SUBJECT: NuScale Power, LLC Supplemental Response to NRC Request for Additional Information No. 71 (eRAI No. 8889) on the NuScale Design Certification Application

NuScale Supplemental Response to NRC Request for Additional Information eRAI No. 8889

eRAI No.: 8889

NRC Question No.: 19-13

Figure 19.1-13: Contribution to Internal Events Core Damage Frequency by Initiator (Point Estimates)

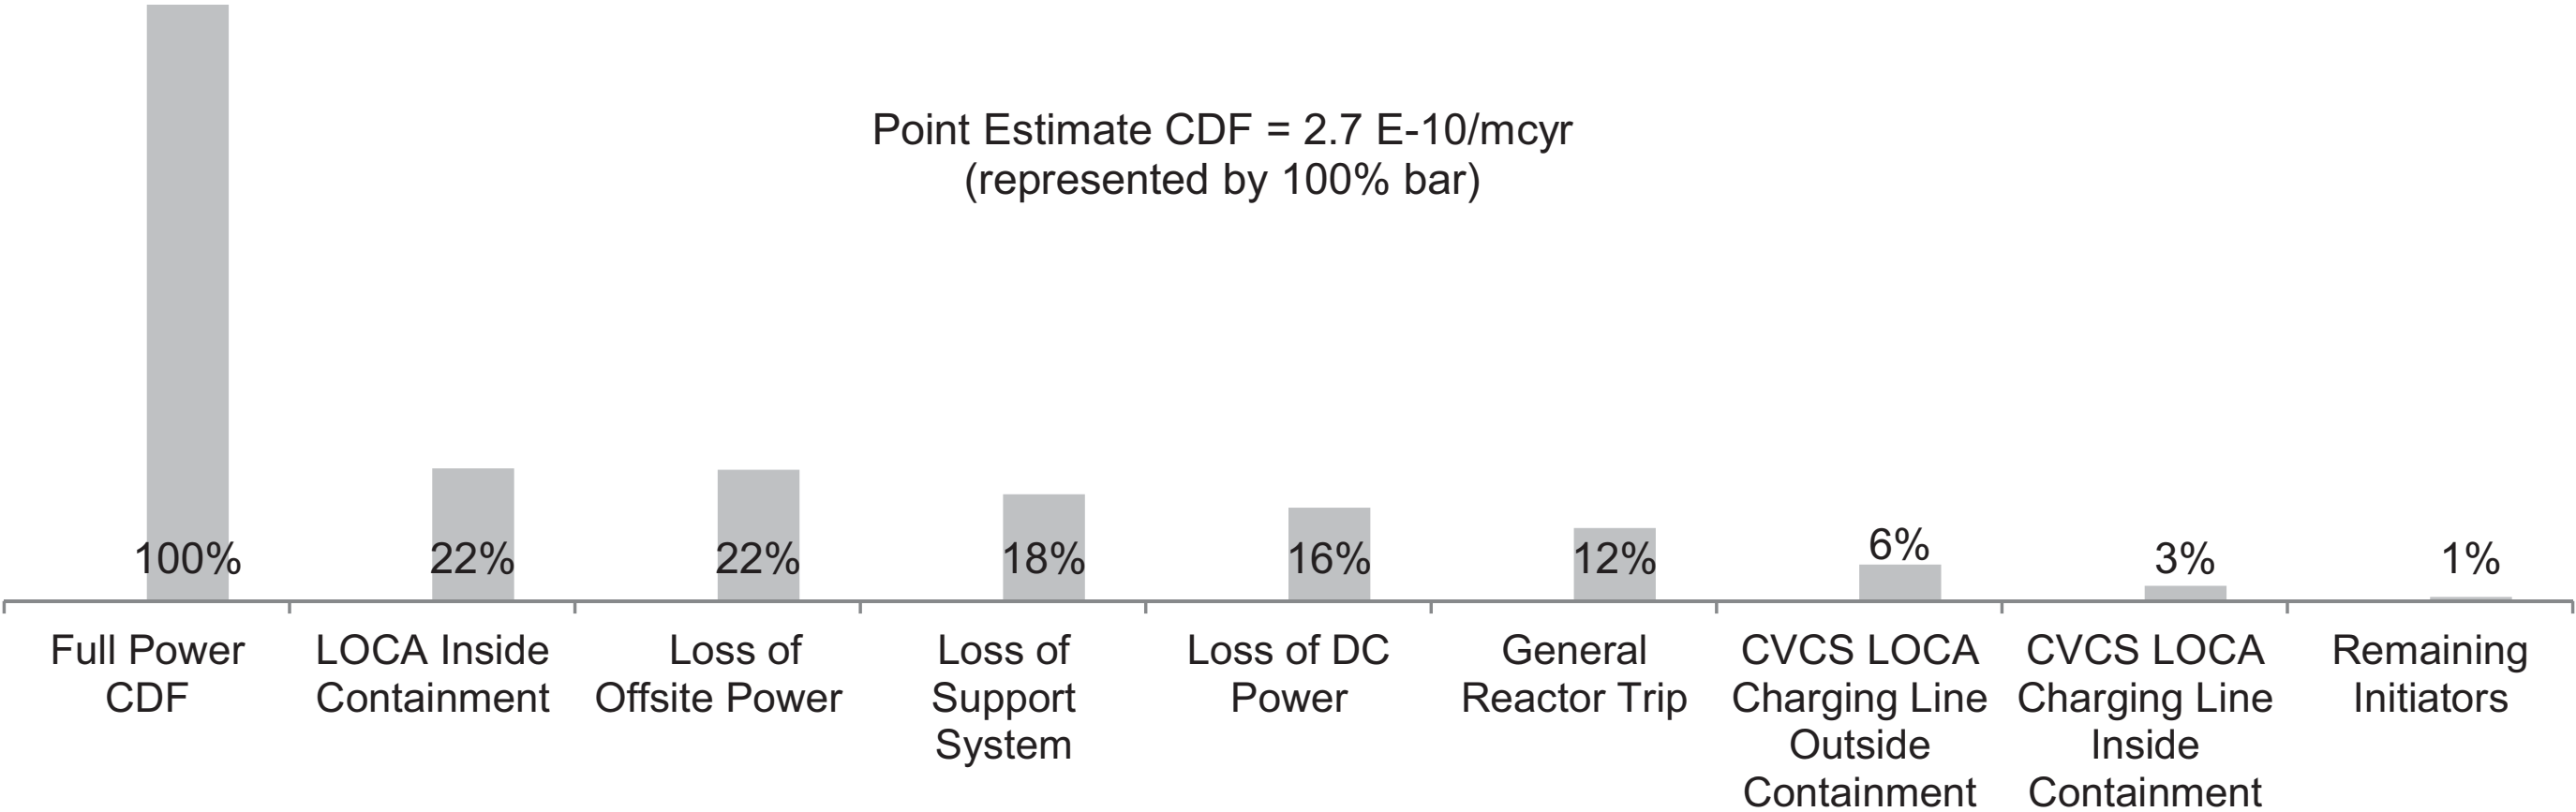
The probability of a thermally induced SGTF has been updated in FSAR Table 19.1-10. This change has a negligible effect on the large release frequency (LRF), as illustrated in the revised LRF values summarized in FSAR Sections 19.1.4.2.2, 19.1.9.1 and Table 19.1-80. The format of Figure 19.1-14 has been simplified and reflects a negligible change in the LRF. There is no change in the core damage frequency; however, the format of Figure 19.1-13 has been modified for consistency with Figure 19.1-14. The change in the probability of a thermally induced SGTF does not introduce new candidates for risk significance.

FSAR Sections 19.1.4.2.2, 19.1.9.1, 19.2.3.3.6; FSAR Tables 19.1-10, 19.1-22, 19.1-28, 19.1-31, 19.1-80; and FSAR Figures 19.1-13 and 19.1-14 have been revised as described in the response above and as shown in the markup provided in this response.
